City of Longville

***Re: Girl Lake Outlet / Boy River Rock Arch Rapids Project
Request for Immediate Interim Corrective Action Pending Completion of Independent
Engineering Review***

ELEVATION AND STREAM DISCHARGE MEASUREMENT REPORT

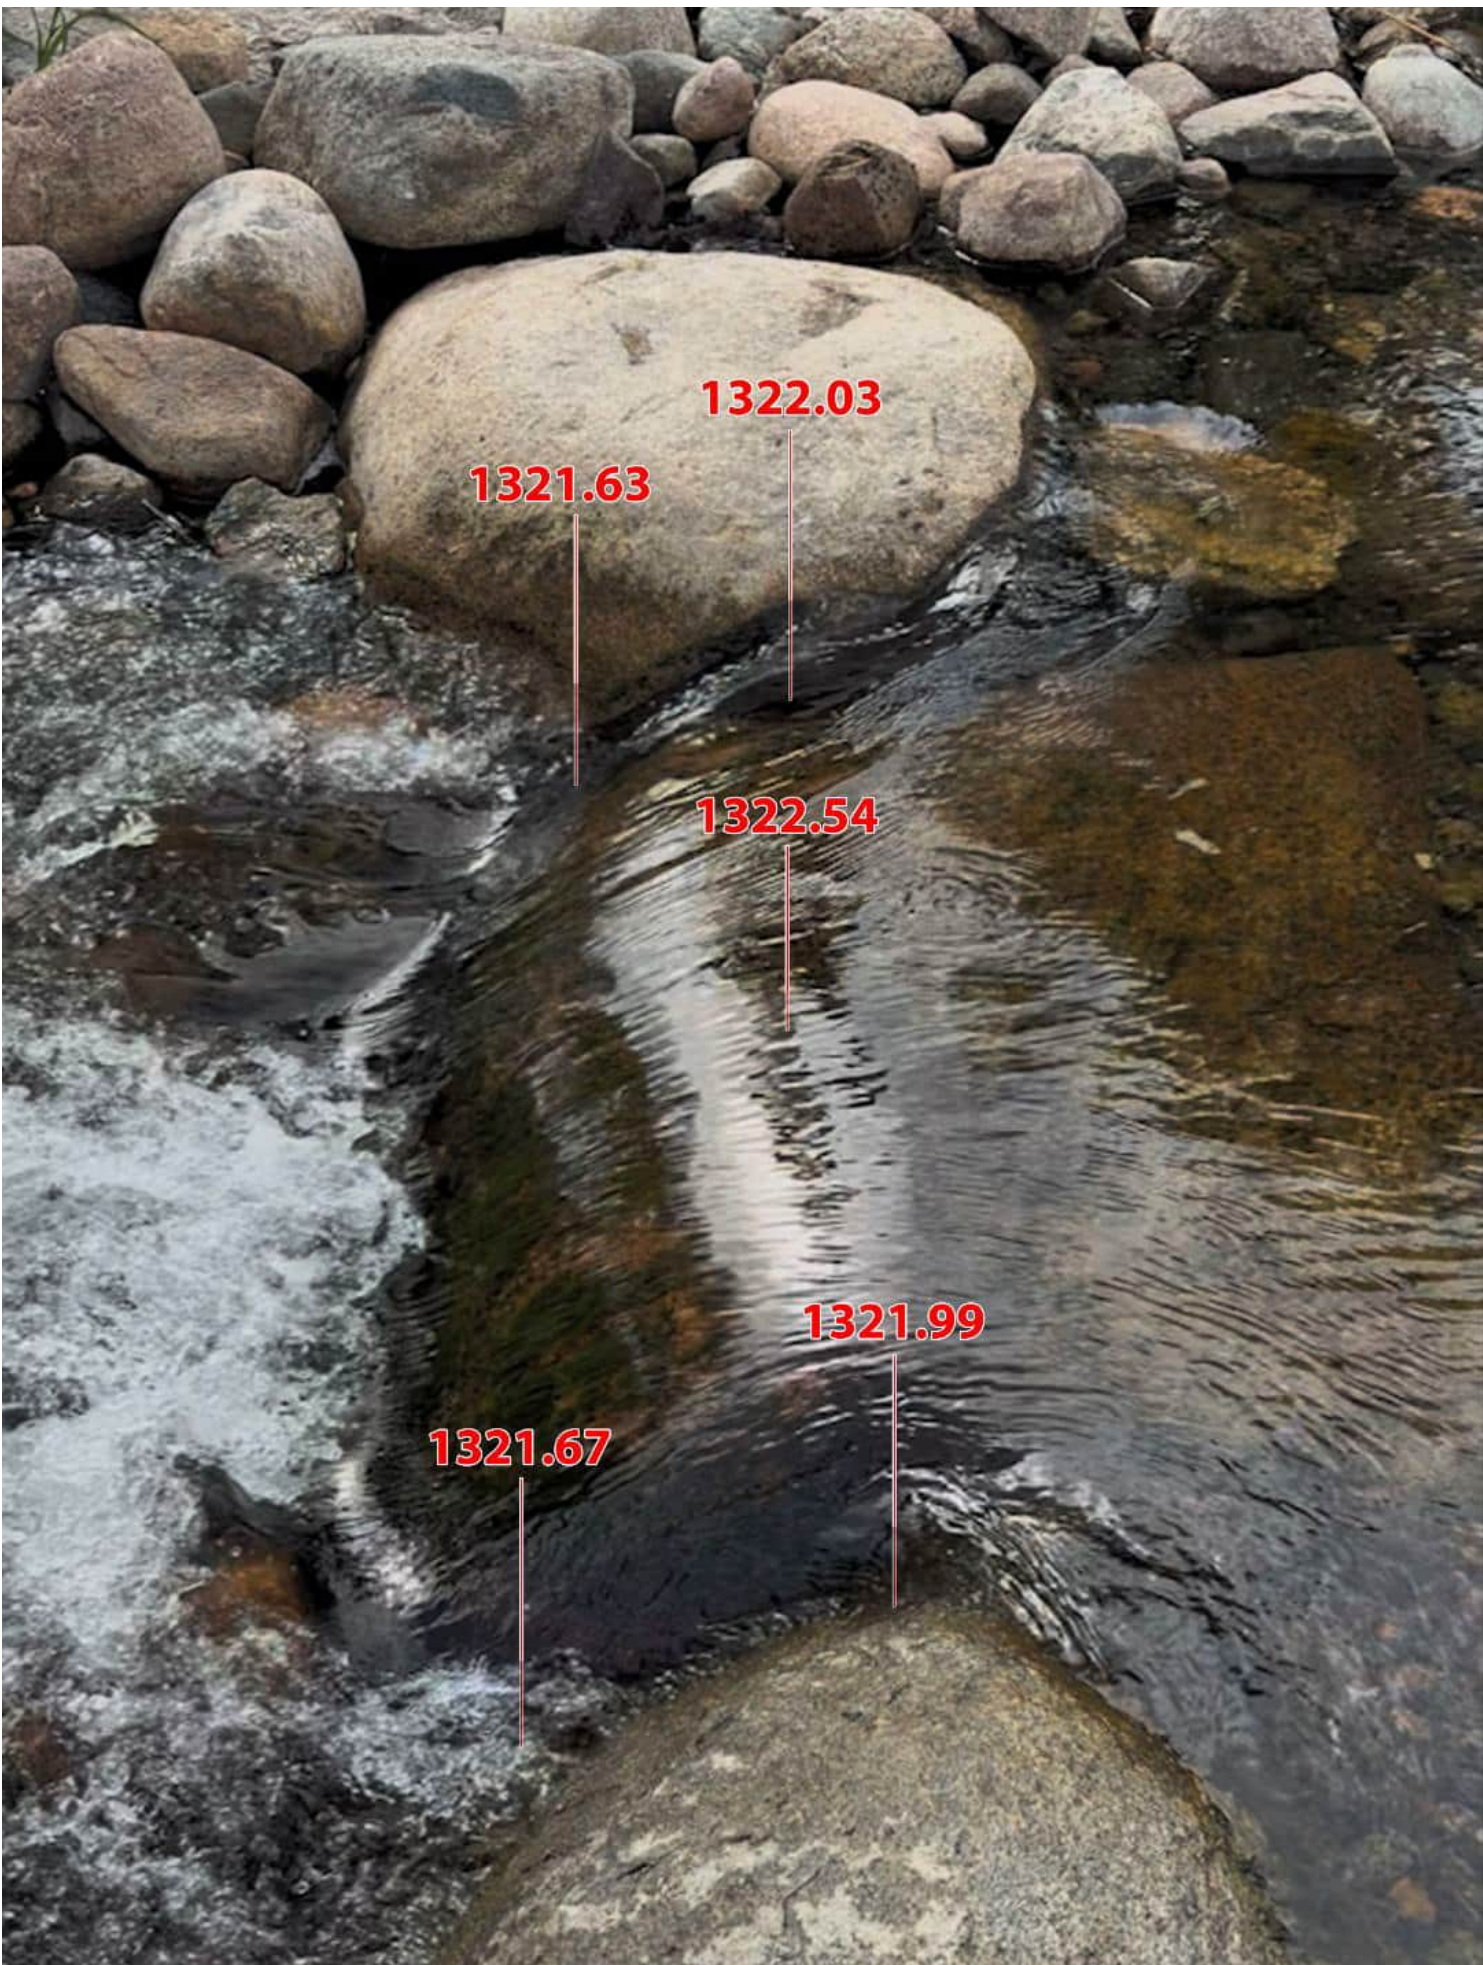
Phase I Survey Identifies Substantially Lower Discharge Paths. The Phase I survey confirms that the principal center crest rock is near and just below the intended design elevation. The surveyed elevation at that location is approximately 1322.54 feet NAVD88.

The survey, however, also identifies substantially lower elevations immediately adjacent to and between the crest rocks through which water is presently flowing. Surveyed elevations at these locations include approximately 1321.63, 1321.67, 1321.99, and 1322.03 feet NAVD88. The attached photographs depict both the surveyed elevations and the actual flow of water through these lower portions of the structure.

The significance is apparent. Although the nominal center crest is near the intended elevation, the center crest is not presently functioning as the effective low-water hydraulic control of the outlet. Water is instead continuing to discharge through lower openings and flow paths, including locations approximately ten to eleven inches below the nominal center crest elevation.

Of particular concern, these lower discharge paths extend below the former low-water runout condition. Thus, at lake elevations at which discharge through the former outlet would have been substantially

reduced or ceased, the reconstructed outlet permits water to continue leaving the lake through the lower portions of the rock arch rapids.

City's Request for Temporary and Reversible Measures. The City therefore respectfully requests that DNR promptly inspect the surveyed conditions and undertake, authorize, or arrange appropriate temporary and reversible measures to prevent continued discharge through the identified sub-crest openings and low points.
